Part One

The Projects and Their Financing

1. This Report addresses questions concerning three IDA-financed projects in Uganda: namely, (1) the Power III Project, otherwise known as the Owen Falls Extension; the Supplemental Loan to the Power III Project; (2) the Power IV Project, which finances power generation Units 14 and 15, (the latter if economically viable); and (3) the Bujagali Hydropower Project.¹

FIGURE 1: PERCENTAGE DIFFERENCES FROM BUJAGALI PAD 'EXPECTED' LOAD FORECAST SCENARIOS

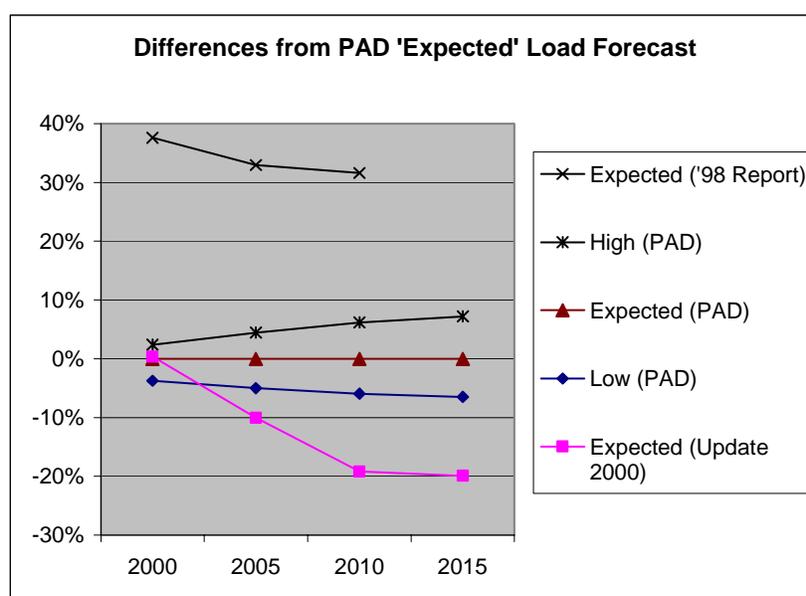
172. Examining Figure 1, it is striking how far the 1998 Report's Expected scenario lies above all the Bujagali PAD scenarios and especially the *2000 Update's* Expected scenario. Moreover, by 2010 the latter lies 20% below the PAD Expected scenario. Figure 1 also shows that between 2000 and 2015 the energy requirements of the PAD High and Low scenarios lie in a band that does not exceed 7.2% more or 6.5% less than the requirements in the Expected scenario, a remarkably narrow range. How do these ranges compare with the ranges for the growth rates of Gross Domestic product (GDP)? Both ranges are shown, for five-year periods, in Figure 2. The Load forecast range lies within and is strikingly narrower than the range of real monetary GDP.

probable Low and High forecasts of energy requirements, shown in Figure 1.¹³⁹ This could imply that the ranges of the individual assumptions are insufficiently broad and/or that the model's structure is not fully sensitive to changes in income.

FIGURE 2: ANNUAL GROWTH RATES OF LOAD FORECASTS AND GDP

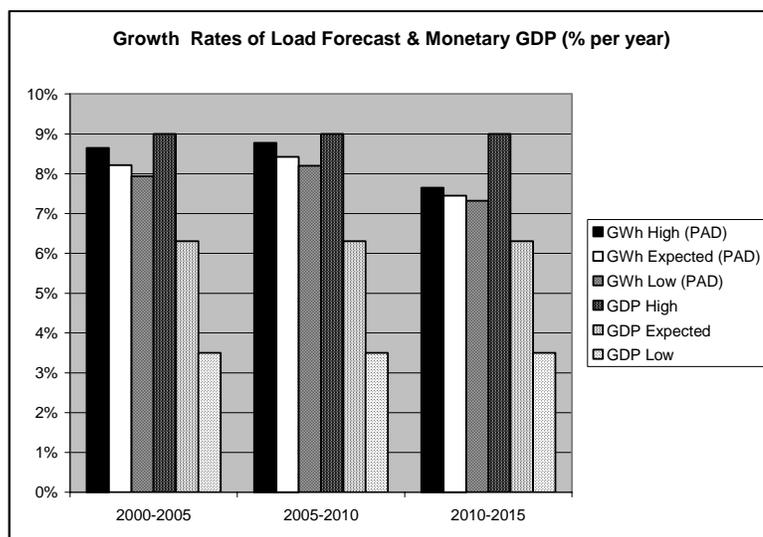
173. According to the Bujagali PAD: *“The demand forecast range between the low and the high [Load Forecast] cases is less than the maximum GDP growth range in the assumptions, because the low and high forecast boundaries were set to avoid making these cases very low probability extremes.”*¹³⁷ Regrettably, they do not then specify the probability criterion by which these boundaries were set, nor provide a fuller explanation for the relative narrowness of the Load forecast's range. This merits discussion, since GDP and its sectoral components play a key role in influencing demand, as the SEDD confirms.
